City of Pembroke Pines
Planning & Economic Development Department
601 City Center Way 3rd Floor
Pembroke Pines FL, 33025

Agenda Date:	October 10, 2024	Application ID:	MSC 2024-0019
Project:	Turbo Shot Coffee Shop	Project Number:	N/A
Project Planner:	Julia Aldridge, Planner / Zoning Technician		
Owner:	Sonny's Enterprises, LLC	Agent:	Angel Pinero
Location:	8579 Pines Boulevard	Commission District:	2
Existing Zoning:	Community Business (B-2)	Existing Land Use:	Commercial
Reference Applications:	SP 92-34, SN 93-26		
Applicant Request:	Architectural and signage modifications to an existing building.		
Staff Recommendation:	Approval		
Final:	<input checked="" type="checkbox"/> Planning & Zoning Board	<input type="checkbox"/> City Commission	
Reviewed for the Agenda:	Director: 	Assistant Director:

Angel Pinero, agent, is requesting approval for exterior architectural and signage modifications to Turbo Shot Coffee Shop (formerly Checkers Restaurant) located at 8759 Pines Boulevard. The existing building was approved through SP 92-34. There will be no changes to the existing building footprint, parking and traffic circulation from the previously approved site plan.

PAVEMENT MARKINGS AND SIGNAGE PLAN

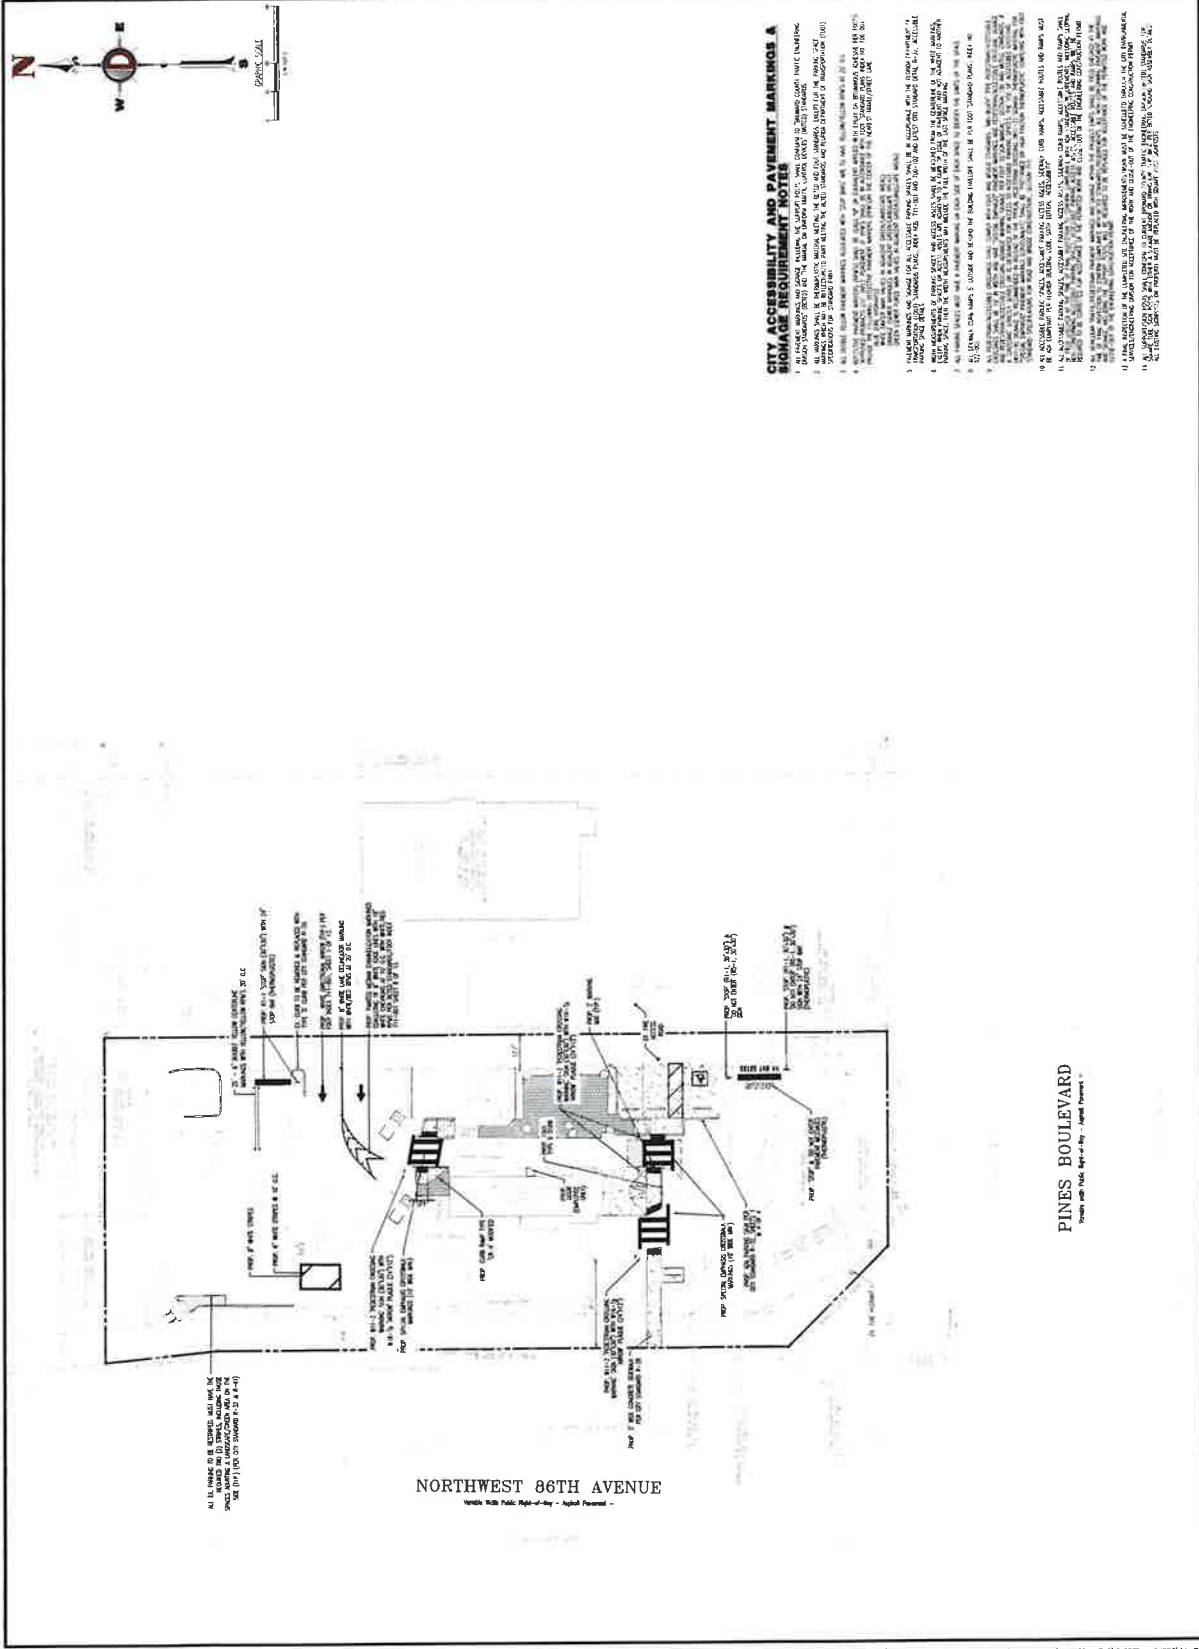
1. It is necessary to depict the column dimensions to clarify that the existing concrete area has been widened to allow for a 36" minimum path adjacent to the existing roof column and the curb edge, and a 42" minimum path adjacent to the existing roof column and the landscape area edge. Clearly show all existing columns on the plans.
2. Depict the existing paver bricks on the plans (show them as a ghost layer) to specify the material that will remain within the scope of work.
3. The wheel stops required 3'(min) space from front wheel stop to front of parking space (typ.) per city detail R-22.
4. The accessible ADA parking space aisle must be stripped with 3-4" white diagonal equally spaced per city detail R-32.
5. No parking area must be stripped with 8" white stripes for the outside and 6" white for the diagonals @ 10' O.C.

6. Depict swale elevations on the plans. It is important to show these elevations to verify that the proposed slopes in the scope of work follow the city requirements. The suggested elevations are marked with an (X) on the plans. The curbs height must be 0.5 ft above the swale. a grading plan is required.
7. The city recommends checking the condition of the existing concrete to determine if it presents potential tripping hazards. If the concrete is found to be in poor condition, it should be repaired and resurfaced in the drive-thru area.

1. Accessible parking spaces are required by code to be a minimum of 19' in length. To provide an accessible route to the covered seating area, a 5' wide accessible sidewalk must be provided per engineering standards. The current location of the accessible parking space may not allow for a compliant accessible sidewalk to the covered seating area due to the existing column closest to the building restricting access.

A 'blow-up detail' to scale based upon existing conditions will be required to be provided as part of the site plan to allow confirmation of a compliant accessible path to the covered seating area and to the designated accessible seating table, etc.

Relocate the accessible parking space to the south side of the parking area and eliminate one (1) standard parking space to allow required 5' concrete sidewalk along the front of the accessible space to fit within the existing island space at the front of the spaces and provide a code compliant minimum 10' wide terminal landscape island at the south end of this parking area and widened landscape area at the north end of the parking area for landscape use.

3. The existing sidewalk to the public sidewalk must be removed & replaced with a 5' wide concrete sidewalk per city standard R-28.
4. Provide 'special emphasis crosswalk markings' (10' wide min.) with w11-2 'pedestrian crossing warning' sign (30"x 30" with w16-7p 'arrow' plaque (24"x12")).

5. Include the existing parking area in the plans. If it is not a parking space provide no parking area striping. 8" white stripes for the outside and 6" white for the diagonals @ 10' O.C.

6. Provide sidewalk curb ramp type 'CR-E' modified and replace exiting sidewalk to provide a 5' min. ADA compliant thickened edge concrete sidewalk up to the existing covered seating area. note that it may be necessary to widen the existing concrete area to allow ADA compliant width at the existing roof column.

8. Provide sidewalk curb ramp type 'CR-E' /'CR-A' modified.
9. Provide sidewalk curb ramp type 'CR-D'.
10. Propose 25' - 6" double yellow centerline markings with yellow/yellow RPM'S 20' O.C, following BCTED pavement marking and signs detail.

11. Depict and denote/label required painted median channelization markings consisting of 8" white edge lines with 18" white chevrons at 10' O.C. with white/red rpms per BCTED standards/FDOT index 711-001 sheet 8 of 13.

12. Depict and denote/label 8" white lane delineator marking with white/red rpms at 20' O.C.
13. Depict and denote/label white directional arrow (TYP.) per FDOT index 711-001, sheet 1 of 13.
